Cotton Field (BD) Ltd (Relocated)

Plot- 42/3, Rajnagar, Sataish Road, Tongi, Gazipur
(23.920396N, 90.363708E)
28th September 2021

Observations

Lower Factor of safety of pile foundations

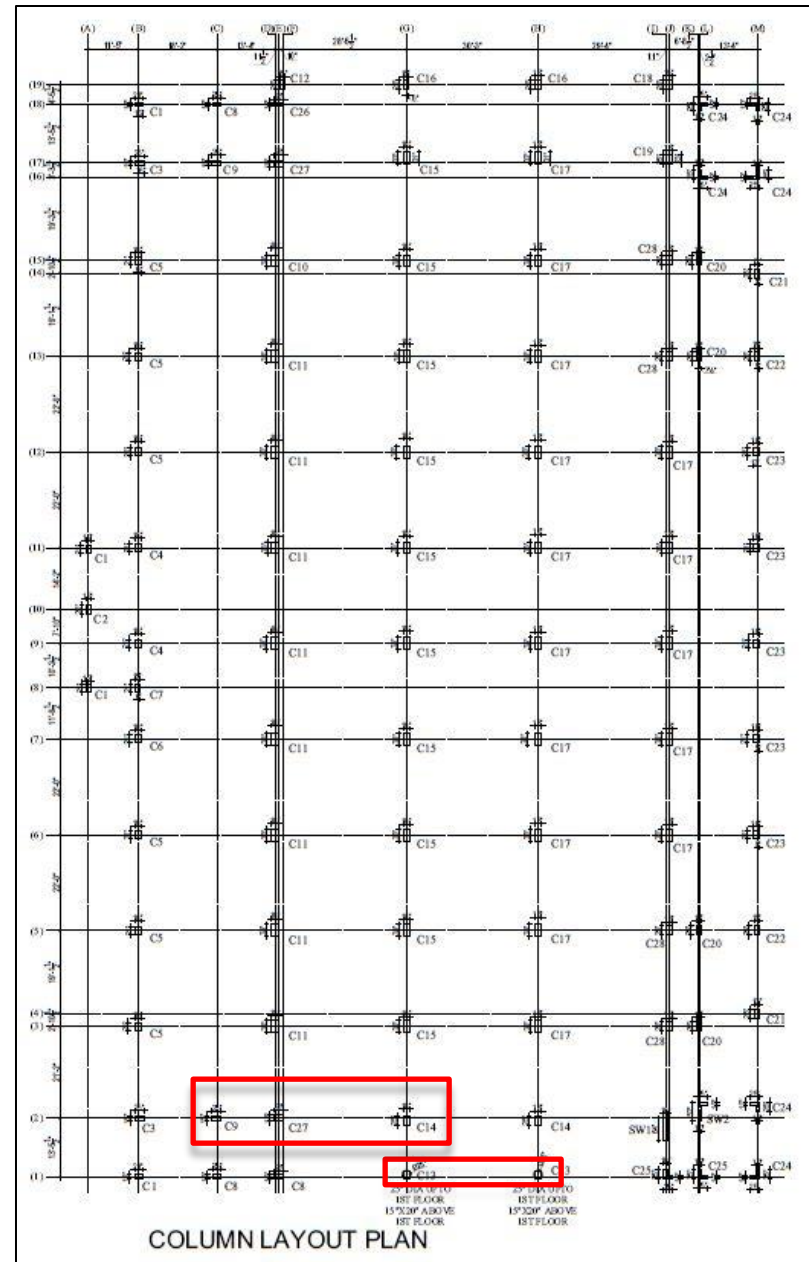
Factor of safety for Pile foundations at grid 1G, 1H, 2C, 2E, 2G were found below 2.50. In the DEA report their no recommendation for those pile foundations.

The factory engineer is required to check the foundation adequacy and suggest proper remedial actions accordingly.

Concrete core sample location

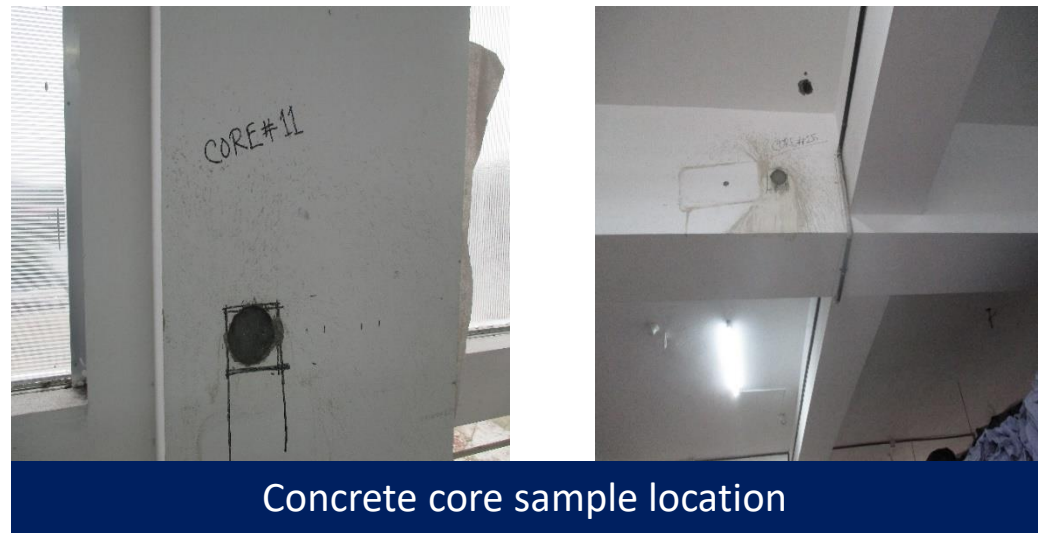
As per core test report and layout plan, 25 number of concrete cores were taken from different locations of beam and column. But we identified only 19 core locations. Factory engineer to identify the missing core locations and revise core layout plan properly.

Slab perforation at 1st floor toilet zone

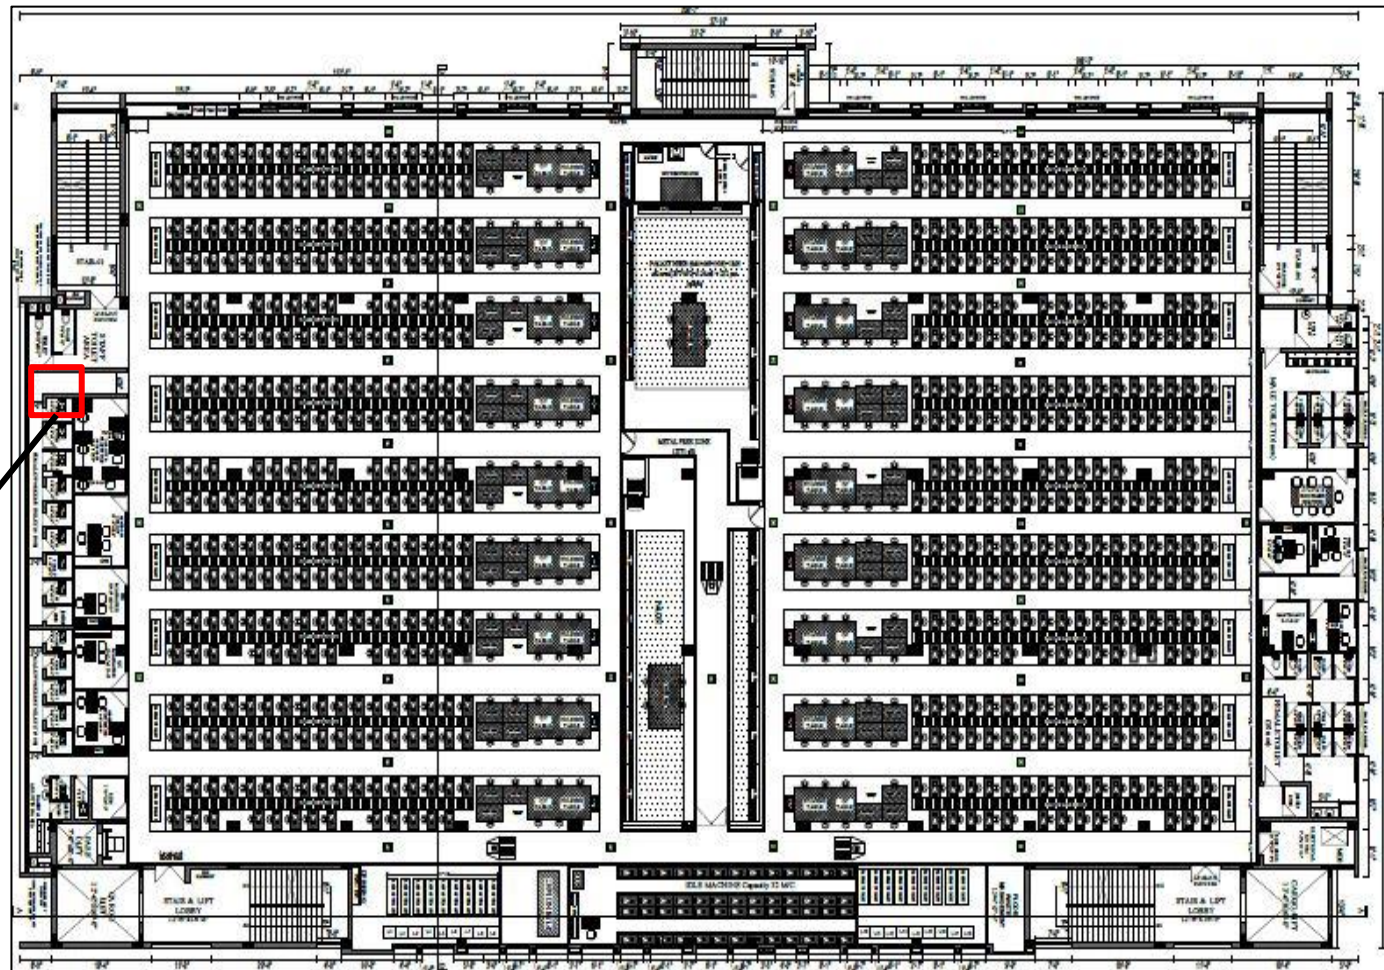
Factory engineer is required to check the adequacy of slab panel having perforation and implement strengthening or remedial works as per engineer's advice.

Pile foundation layout

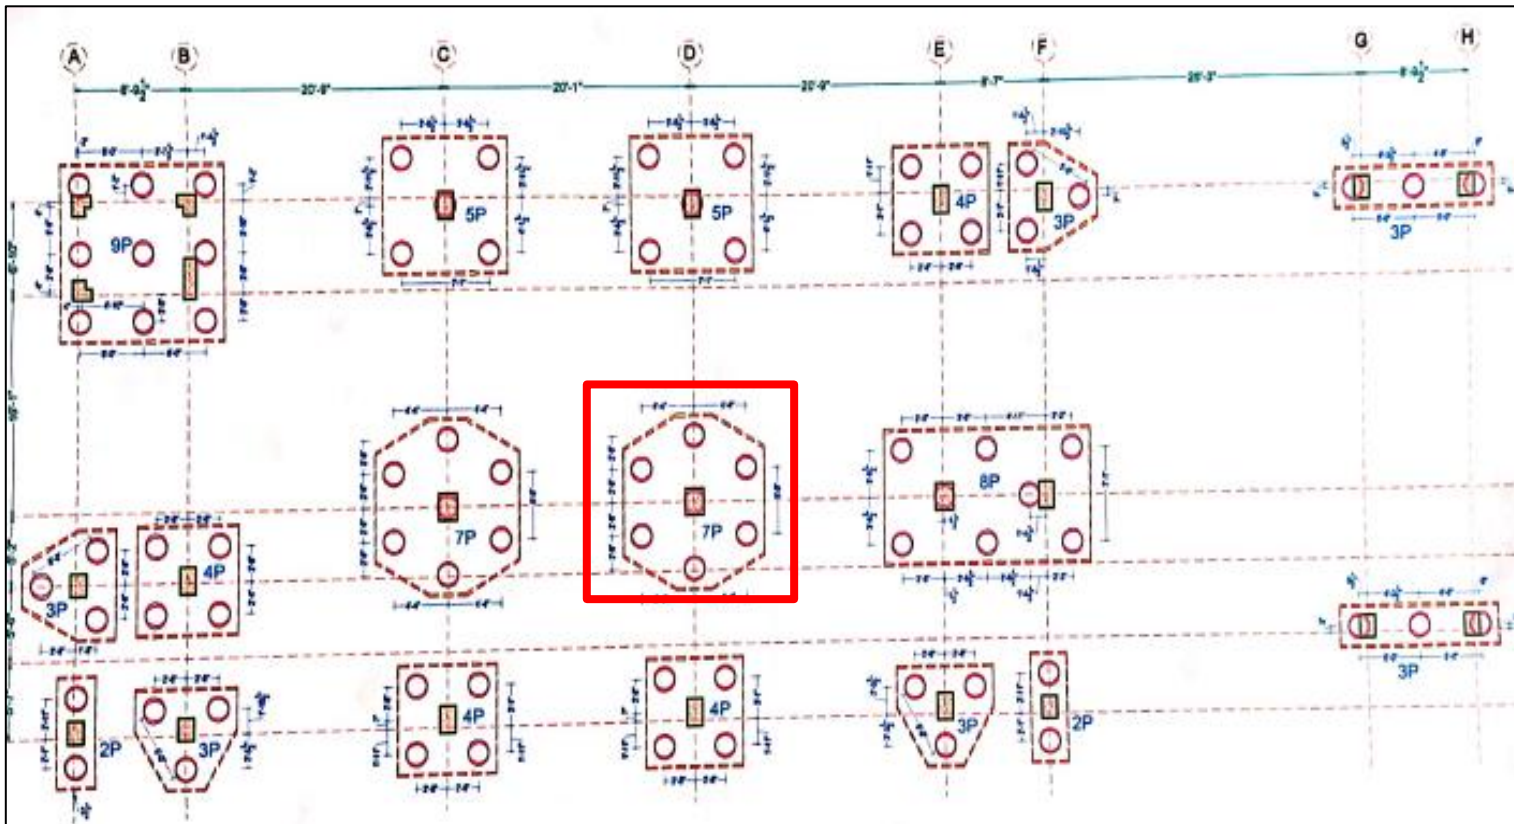
Cursory calculation indicate that the factor of safety of marked pile foundation is below 2.50 considering live load 3 kPa on typical floors, 1.5 kPa on roof & each pile capacity from soil test report (30 ton). The factory engineer is required to check the foundation adequacy and suggest proper remedial actions accordingly.

2nd floor & 3rd floor layout

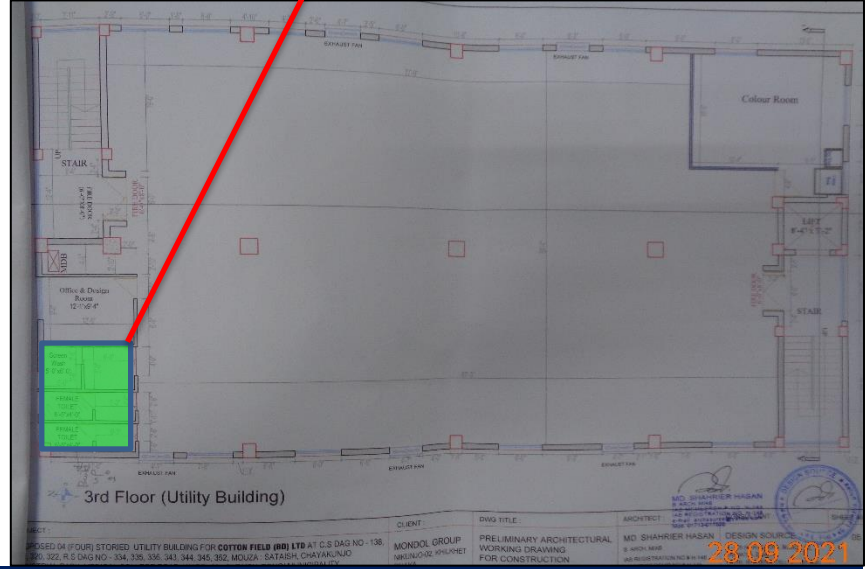
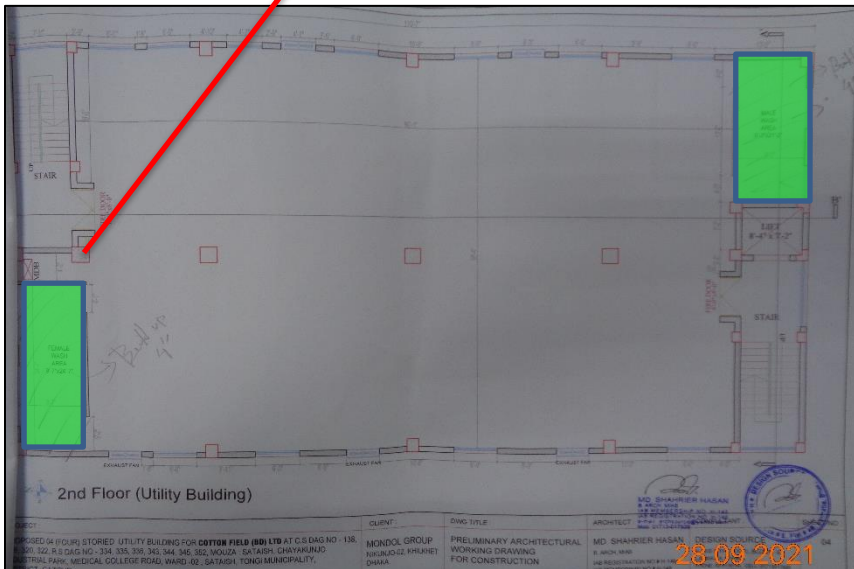
Approx. 100mm build-up was found in toilet area which is not mentioned in as-built drawing. The factory engineer to survey the structure and update the as-built drawings accordingly.
